# Oregon Roof Consulting and Inspection

Roof Inspection for : [REDACTED]  
Job Address : [REDACTED] 97219

I inspected this roof on September 2<sup>nd</sup> 2022. I met the owner and got on the roof. The roof is a new GAF peel & stick granulated membrane. One layer over planks / boards. Separate photo emails will be sent. Each photo email will be numbered to correspond to the numbered items on the summary report. The following items should be noted :

**FLAT EDGE FLASHING DETAIL**

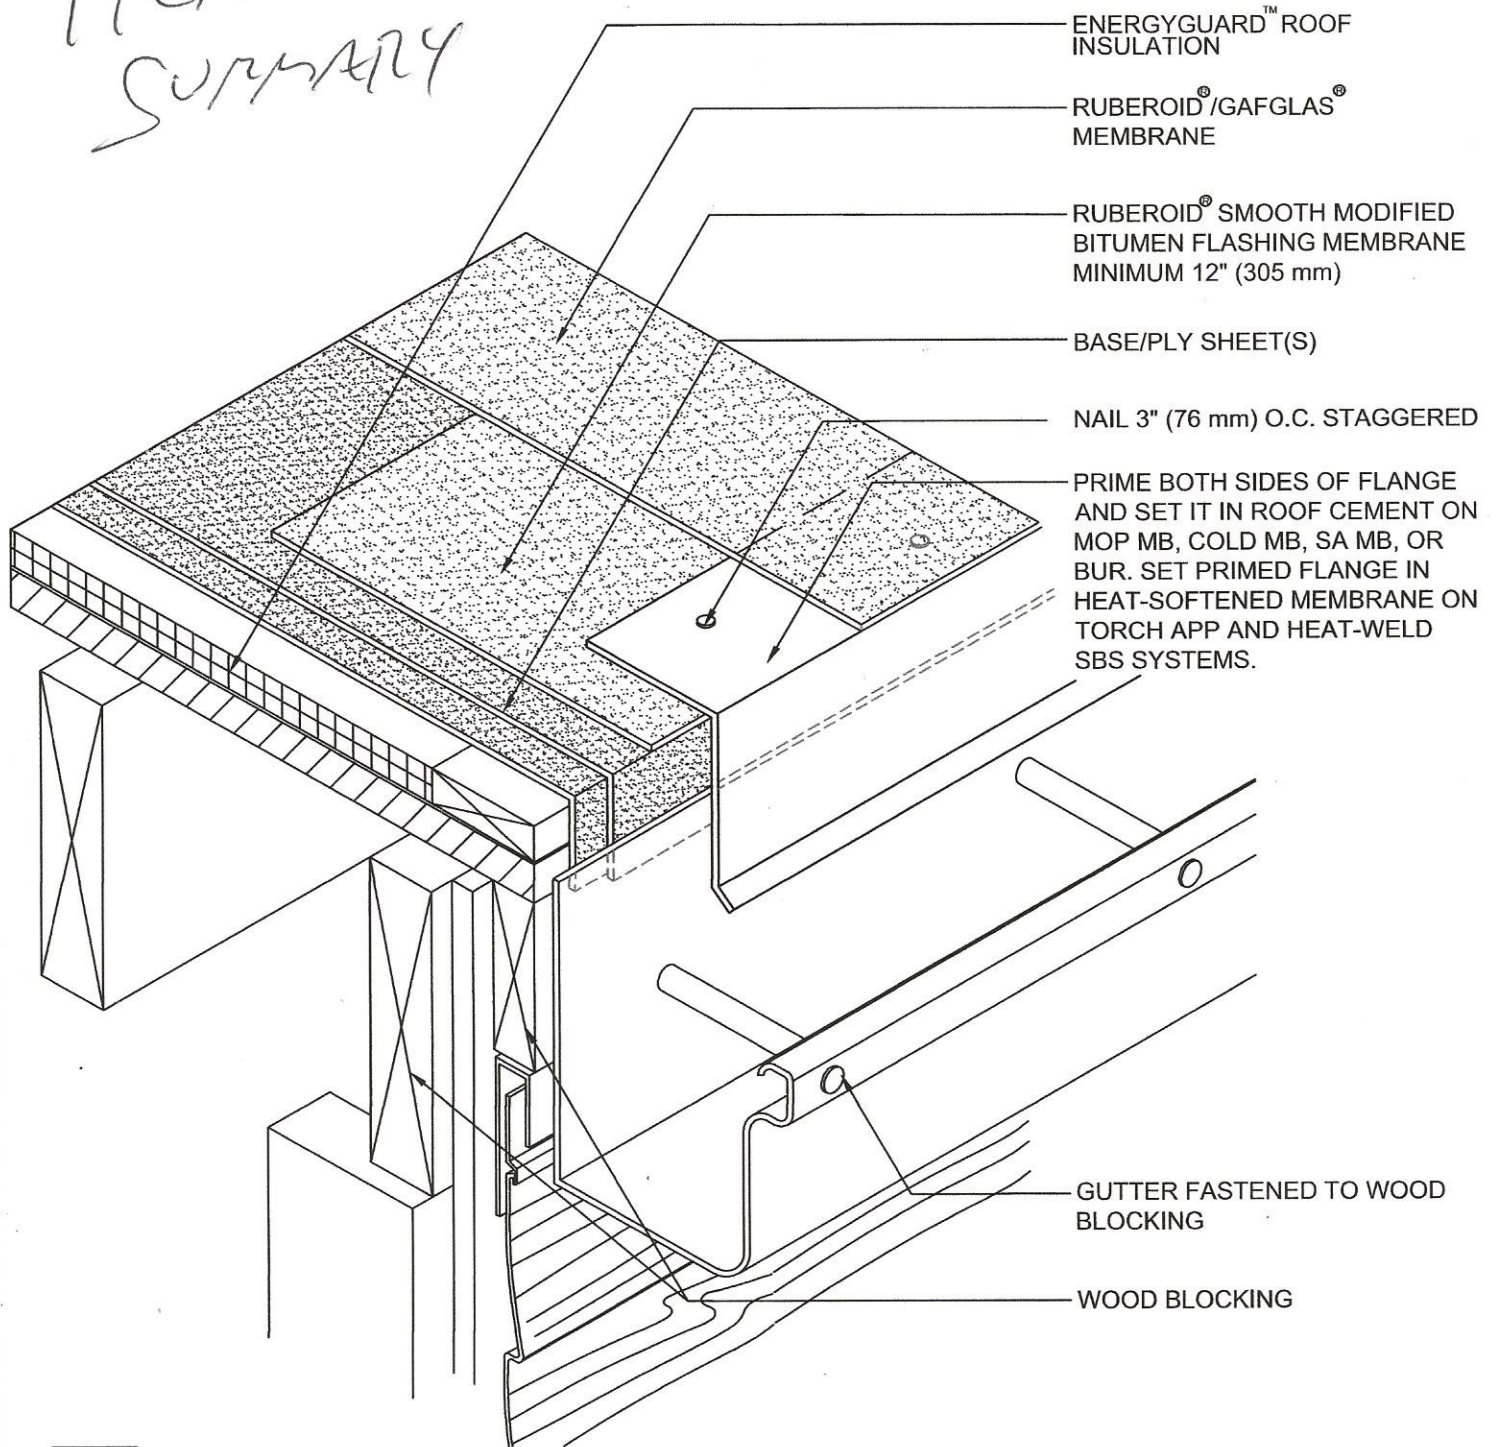
1. The contract specified a TPO membrane roof. This is not a TPO membrane roof. It is a peel and stick granulated membrane. I am certainly no lawyer nor do I pretend to be one but I think real lawyers refer to this as "Breach Of Contract". It is always wise to abide by the contract that ( you ) write.
2. This roof was not correctly / professionally installed. All details are not remotely close to being correct.
3. I had GAF send me their specs for modified / BUR roof systems. I forwarded these to the homeowner. I will attach some of these to this summary report.
4. Underlayment must be wrapped over edges. This was not done.
5. All perimeter flashing must be 'sandwiched' between plies of membrane. This was not done.
6. Roof to wall and roof to sides of chimney incorrect.
7. All vent and pipe flashing flanges must be primed and sandwiched between plies of roofing. This was not done.

ITEM 5 OP SUMMARY

1. BASE/PLY SHEET(S) TURNED OVER EDGE A MINIMUM OF 1 1/2" (38 mm) OR THICKNESS OF NAILER, WHICHEVER IS GREATER, OR A SEPARATION MEMBRANE SHEET IS INSTALLED AS SHOWN.
2. THIS DETAIL SHOULD BE USED ONLY WHERE WATER DRAINS AWAY FROM EDGE.
3. PRIME BOTH SIDES OF FLANGE AND SET IT IN ROOF CEMENT ON MOP MB, COLD MB SA, MB AND BUR. SET PRIMED FLANGE IN HEAT-SOFTENED MEMBRANE ON TORCH APP AND HEAT-WELD SBS SYSTEMS.

**PERIMETER GUTTER DETAIL**

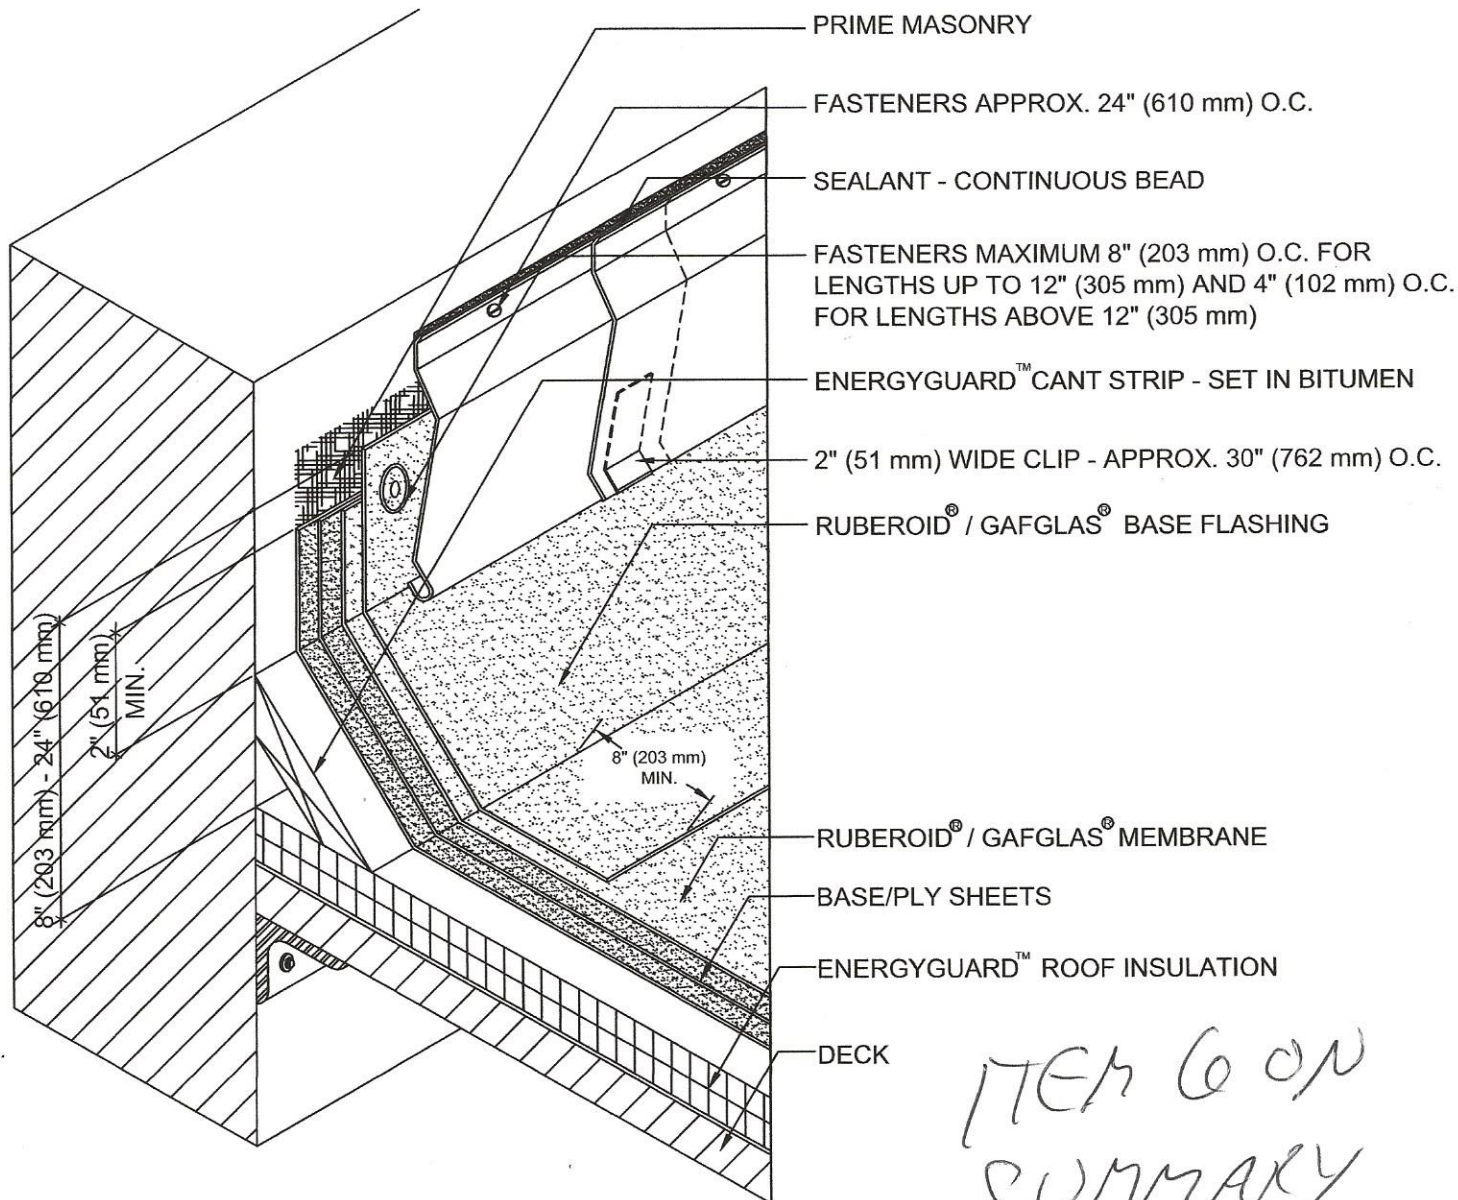
ITEM 5 ON SUMMARY

1. BASE/PLY SHEET(S) TURNED OVER EDGE A MINIMUM OF 1 1/2" (38 mm) OR THICKNESS OF NAILER, WHICHEVER IS GREATER.
2. FOR DRAINAGE OVER EDGE, USE METAL WITHOUT GRAVEL STOP LIP.

www.gaf.com 1 Campus Drive. Parsippany, NJ 07054	<b>GAFGLAS®</b> Built-Up Roofing Systems <b>RUBEROID®</b> Modified Bitumen Roofing Systems	<b>WALL FLASHING WITH SURFACE-MOUNTED COUNTERFLASHING</b>	DRAWING #	SYSTEM
			302	MB/BUR
			SCALE	ISSUE/ REVISION DATE
			N.T.S.	10-13-15

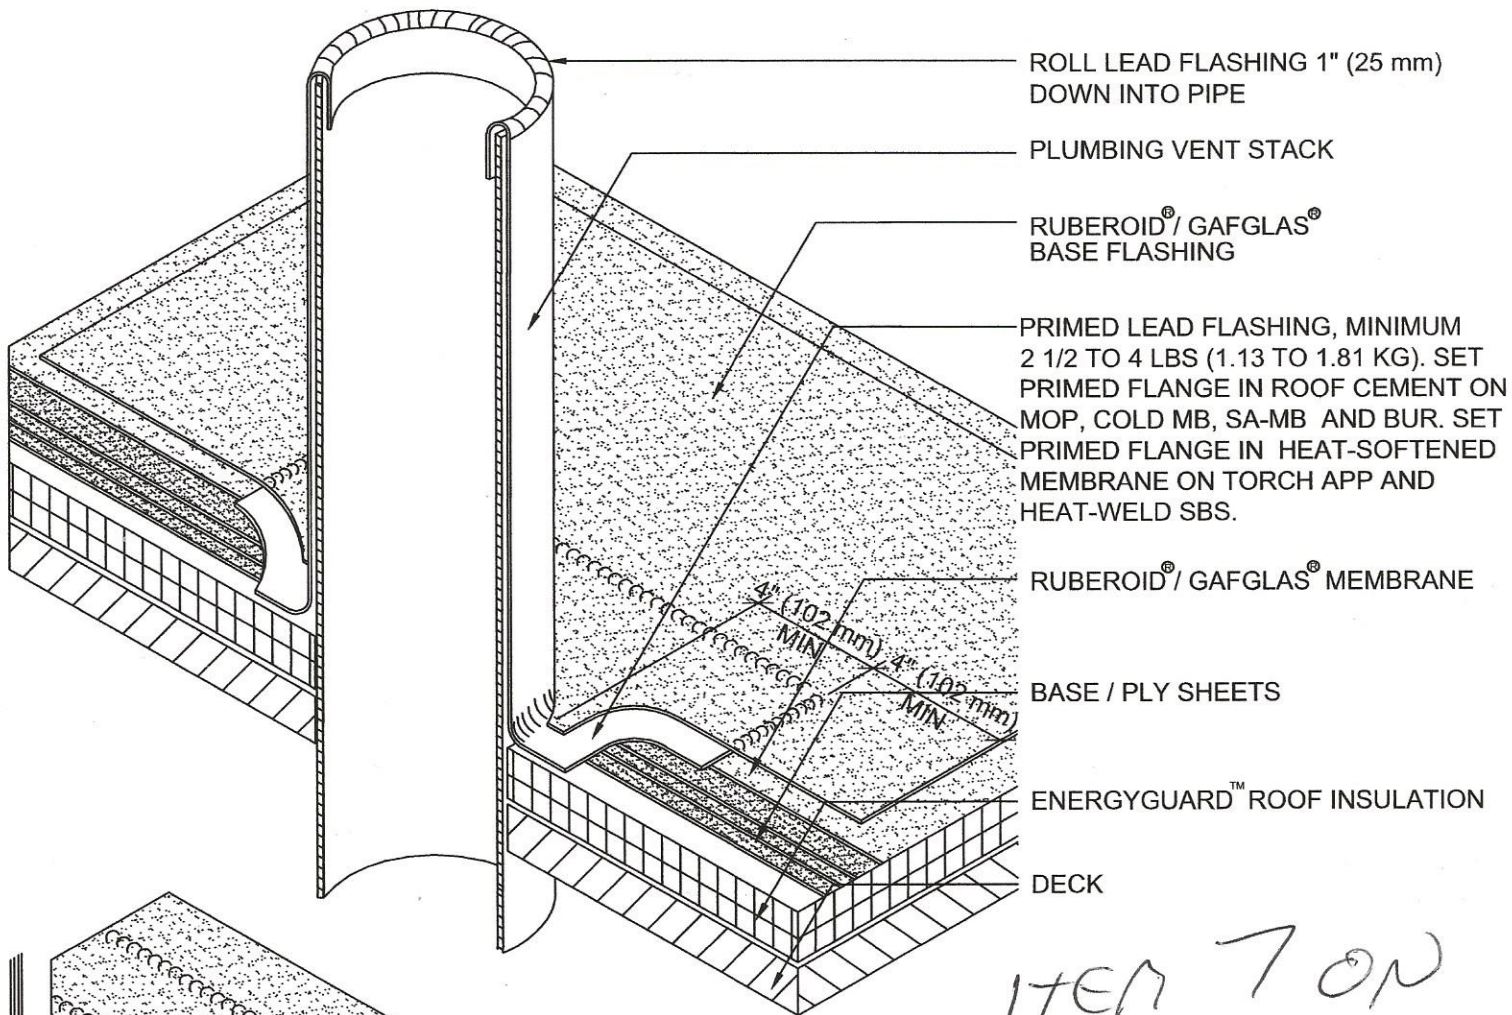
ITEM 6 ON SUMMARY

1. WHEN PARAPET WALL EXCEEDS 24" (610 mm) IN HEIGHT, REFER TO DETAIL MB/BUR 6, "HIGH PARAPET WALL."
2. MASONRY WALLS TO BE PRIMED PRIOR TO FLASHING. WOOD WALLS REQUIRE BASE SHEET NAILED TO WALL 8" (203 mm) O.C. ALONG TOP AND LAPS AND 8" (203 mm) O.C. THROUGHOUT THE FIELD OF THE BASE SHEET ON THE WALL.
3. BASE FLASHING ON ALL 15- & 20-YEAR GUARANTEE SYSTEMS MUST HAVE A BASE PLY. REFER TO FLASHING MEMBRANE APPLICATION AND FLASHING SPECIFICATION PLATES.
4. SEALANT AT TOP OF SURFACE-MOUNTED COUNTERFLASHING IS A MAINTENANCE ITEM AND MUST BE MAINTAINED THROUGHOUT THE LIFE OF THE ROOF TO ENSURE A WATERTIGHT SEAL.

**VENT STACK FLASHING DETAIL**

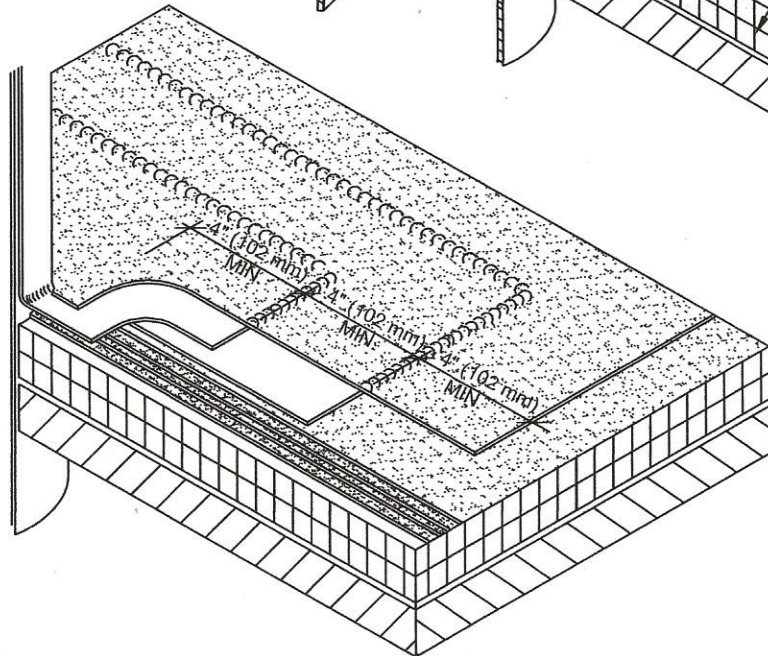
ITEM 7 ON SUMMARY

1. SHEET LEAD MINIMUM OF 2-1/2 (1.13 KG) POUNDS PER SQUARE FOOT.
2. MINIMUM 18" (457 mm) CLEARANCE FROM PIPES, WALLS AND CURBS.
3. FOR HEAT-WELD™ OR TORCH-APPLIED RUBEROID® MB, TORCH THE AREA OF RUBEROID® MB OVER WHICH THE METAL IS TO BE PLACED TO A MOLTEN STATE. PRESS THE PRIMED FLANGE INTO THE MODIFIED BITUMEN WHILE IT IS STILL MOLTEN.
